Reg.12-10/A.12-10-009
SDG&E CNF PTC Application

Subject: CNF ED07-SDGE REVISED RESPONSE.

A.12-10-009 Cleveland National Forest Power Line Replacement (CNF) Projects PTC

ED07-SDGE: Question 1

Existing view from Golden Acorn Casino (KOP 3)

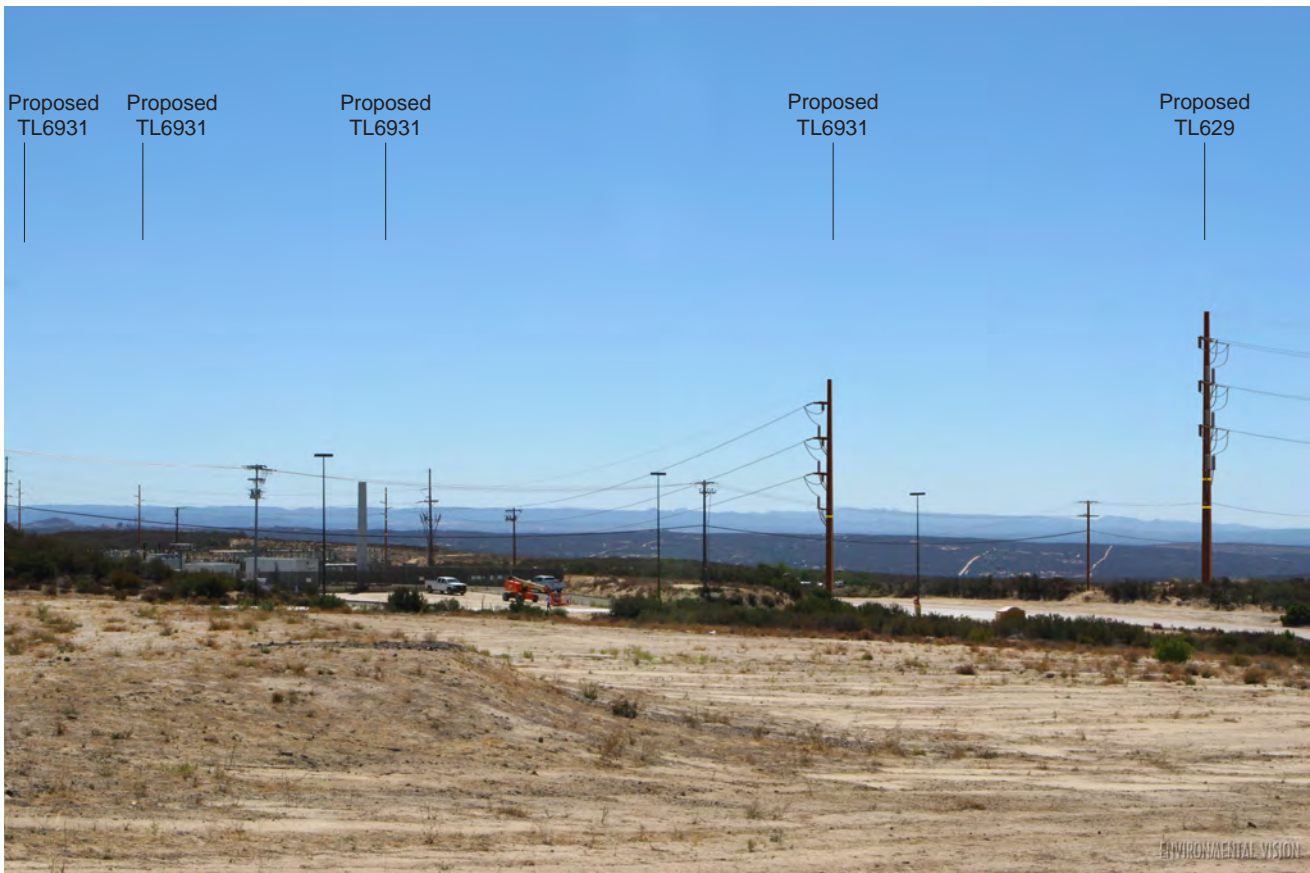
- a. **As the pole heights appear different in the simulation, please confirm the modeled heights of the two riser poles in KOP3 (proposed TL6931 and proposed TL629 on right side of photo).**

- b. **Please confirm these are riser poles.**

- c. **Please provide the .jpg of simulation without annotations.**

SDG&E Response: The modeled pole height for both riser poles shown in KOP 3 is 130 feet.

SDG&E Response: Both of these poles are modeled as riser poles, as shown in the simulation.

SDG&E Response: The .jpg file of this simulation without annotations is attached.

Existing view from Crestwood Substation looking southeast (KOP 16)

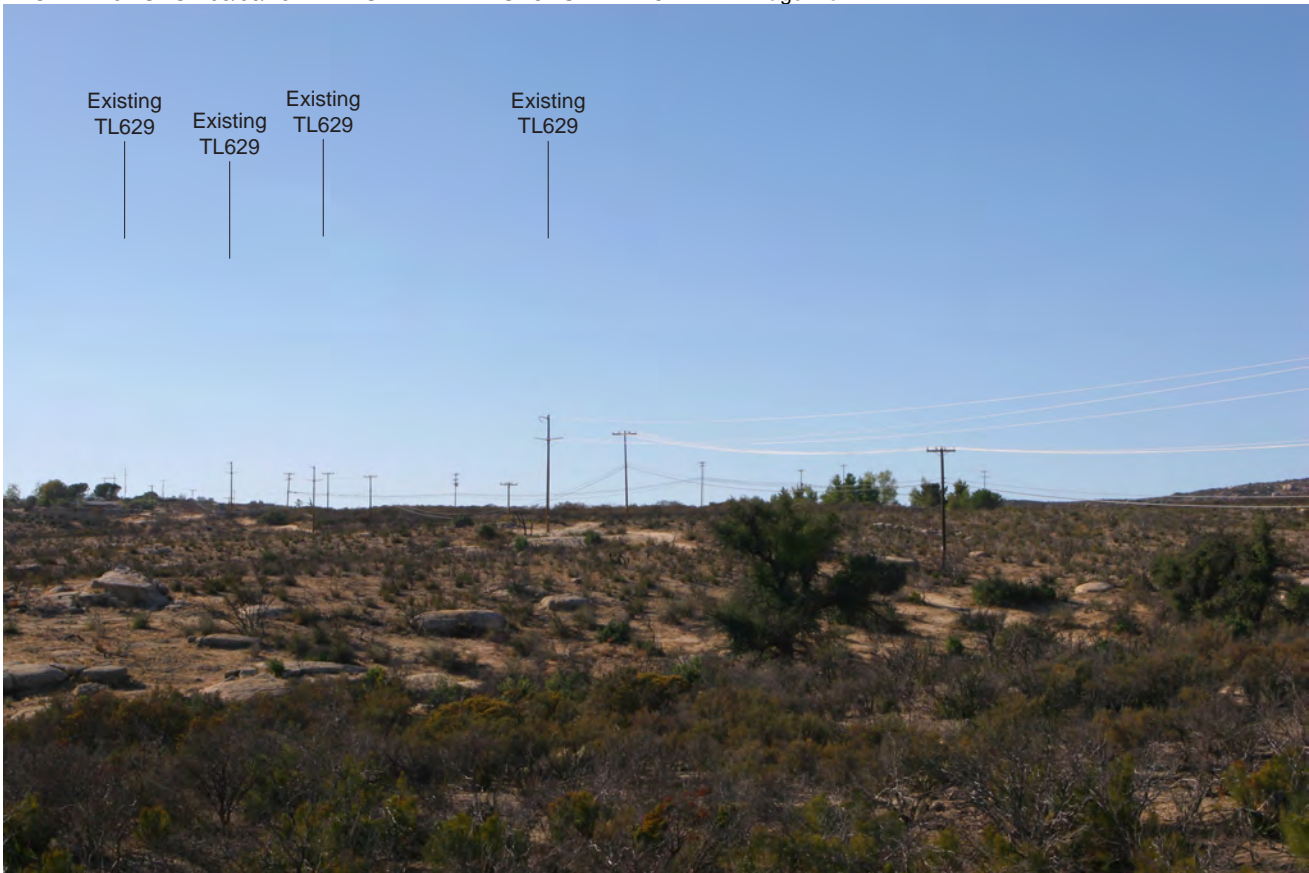
- a. **Existing Photo (see image below): In order to know which TL the unlabeled pole is associated with in the photo, please label the pole located between the Existing TL629 pole and Existing TL6931 pole (marked in red below).**

- b. Visual Simulation (see second image below): depicts a single new TL6931 riser pole where these 3 existing poles are located. Please confirm if the third pole is removed and replaced with a single, larger steel pole associated with TL6931 or TL629.**

SDG&E Response: The unlabeled pole shown in the existing conditions photograph for KOP 16 is not associated with either particular line, but contains a nonstandard tie switch to connect the two tie

lines together. Because the lines entering Crestwood Substation at this location share an underground conduit package and due to the current configuration of the substation itself, this tie switch is necessary to allow the 69 kV power lines to stay online while the substation is offline for maintenance. The attached simulation includes the label "TL629/TL6931" for this pole.

SDG&E Response: The tie switch pole will be removed along with the two existing riser poles at this location; one steel riser pole, which will be associated with TL6931, will be constructed in their place.
